# **Safety Evaluation Report**

## **Related to the License Renewal of the Millstone Power Station, Units 2 and 3**

Docket Nos. 50-336 and 50-423

Dominion Nuclear Connecticut, Inc.

**Figure A: Trend Line Relationship with Horizontal Tendons**

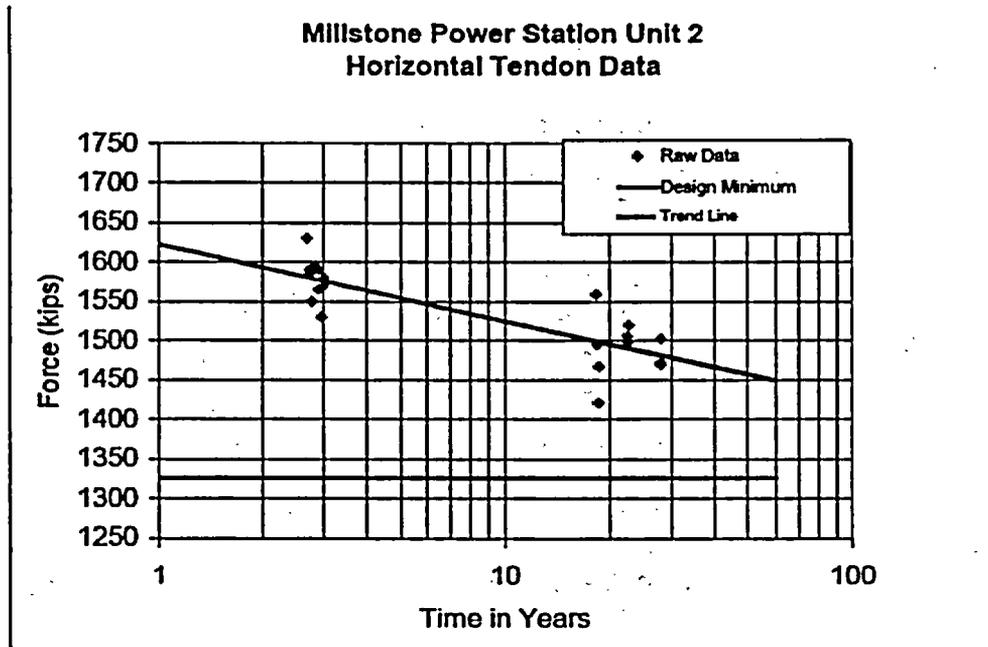
In its January 11, 2005 response, the applicant removed the tables provided in the LRA, and substituted new tables showing measured prestressing forces during tendon inspections for

each group of tendons. In response to the staff's follow-up question as to why 3-, 5-, and 10-year data are missing from the tables, the applicant stated that as these tendons went through repeated tensioning and detensioning, the data were not reliable. The measurements taken during the 1-, 15-, 20-, and 25-year inspections were used for developing the trend lines. In Figures 1, 2, and 3 of the revised response (dated January, 11 2005), the applicant provided the trend lines and the measured tendon force data. Figure A, showing the trend line related to horizontal tendons, is reproduced below:

In RAI 4.5-5, the staff noted that the process used by license renewal applicants with respect to prestressed concrete containments is to assume that the tendon force varies with the logarithm of time (as discussed in RG 1.35.1). The staff indicated that it was not apparent in Figure 4.5-1 what functional relationship had been assumed between the two variables. The applicant was requested to provide additional information regarding the process used in arriving at the trending curves shown in Figure 4.5-1.

As presented in the responses to RAI 4.5-4 (Figures 1, 2 and 3) and RAI 4.5-5 (Figures 1, 2 and 3), projected lockoff forces (Millstone Unit 2 LRA, Section 4 – Figure 4.5-1) remain above minimum requirements over the period of extended operation.
